INITIAL FIRE SAFETY INSPECTION REPORT

Mashiyat Apparel Ltd.

RSC ID: 26392

Date: 12-Aug-2025

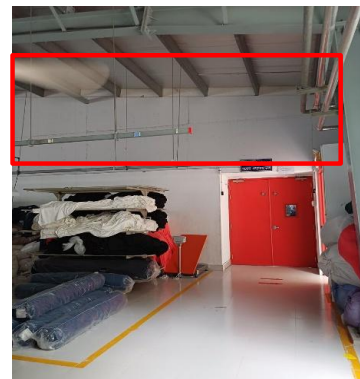
F-08	Fire Rated Construction	<p>Dining (E4) area is not separated from medical (D1) due to unsealed penetration. Additionally, single exit has been provided in dining.</p> <p>Location: Ground floor, Admin building.</p>	<p>Separate the dining area from other occupancies with 3-hr fire rated construction, provide minimum 3-hr. rated doors for the openings and seal the unprotected penetrations.</p> <p>Provide required exits that lead directly to the street or exit stairwell or leading to a corridor or open space.</p>	Within 3 months
------	-------------------------	--	--	-----------------
